18 May 2017

WM Project Number: 14288
Our Ref: LT180517 CondS96

**Re: SCEGGS Redlands - SSD 6454
Revised Condenser Area for Stage 1 New Learning Hub**

Figure 1: Locations of Condensers Areas with respect to 18 Gerrard Street

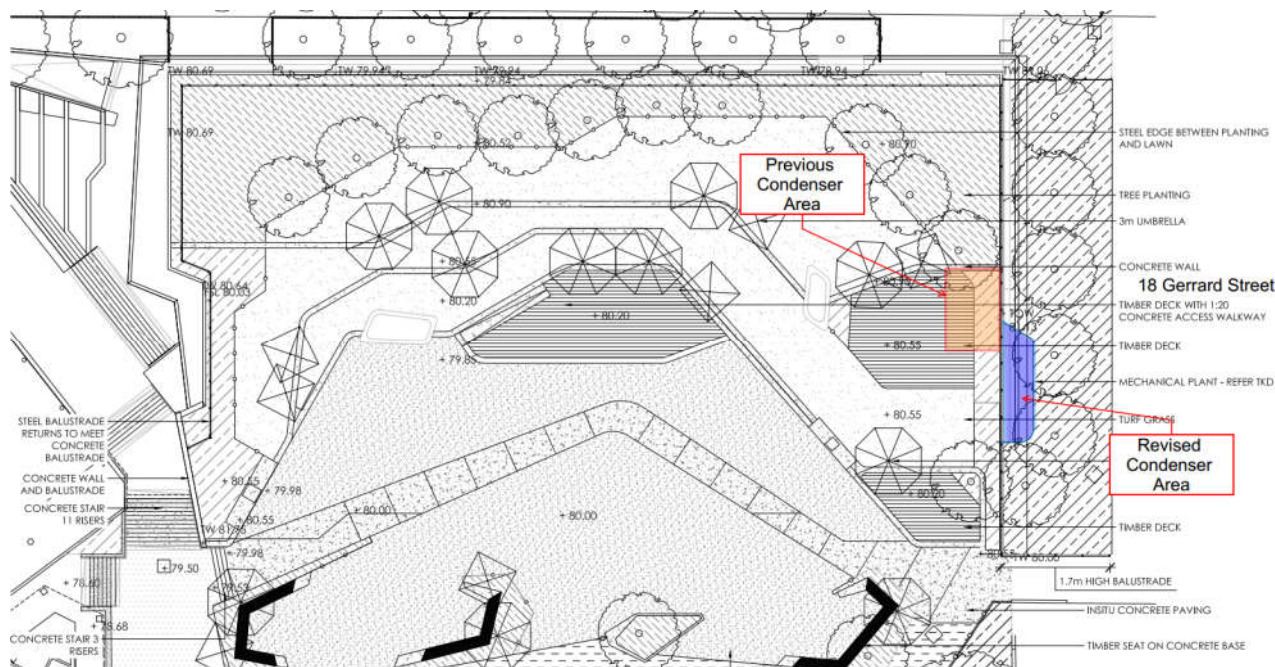
Since the approval, the location of the condenser plant area associated with the interim Music facility has been revised from a location on top of the landscaped area to a relocated and integrated into the podium structure approximately 2 metres to the East of the initially proposed location. As a result, the mechanical plant associated with this area is slightly closer to the residence at 13 Gerrard Street.

Accordingly, a review of selected plant and site specific noise criteria has been conducted to ensure that the acoustic amenity of residences is not compromised and is consistent with the project application report and the conditions of consent.

Figure 2: Mitigation Measures

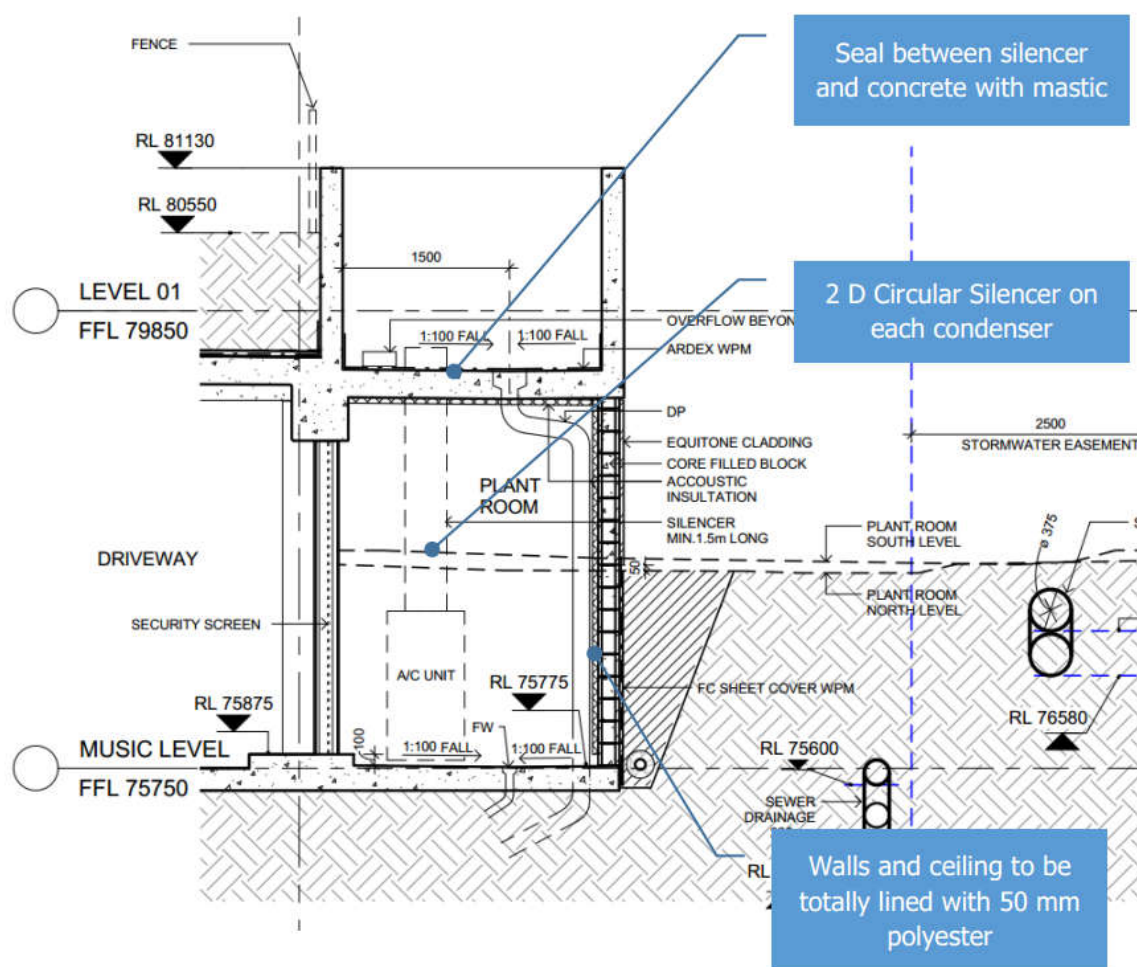
The revised location includes the following noise control measures that have been adopted to ensure that compliance with the site-specific noise criteria that has been detailed in the Project Application will be achieved and that the relocation of the plant room does not result in any additional environmental impact due to noise.

- The condenser plant is in a plant area that is contained in the new facility carpark below ground level. As a result, noise from the condenser intakes will be contained to the inside of the carpark.
- The outlets of the condensers have 2D circular silencer installed on top of the units.
- Internal walls are to be lined with acoustic absorption material.
- The condenser units that may operate in the evening are to be set on night mode to further reduce noise generated by the units.
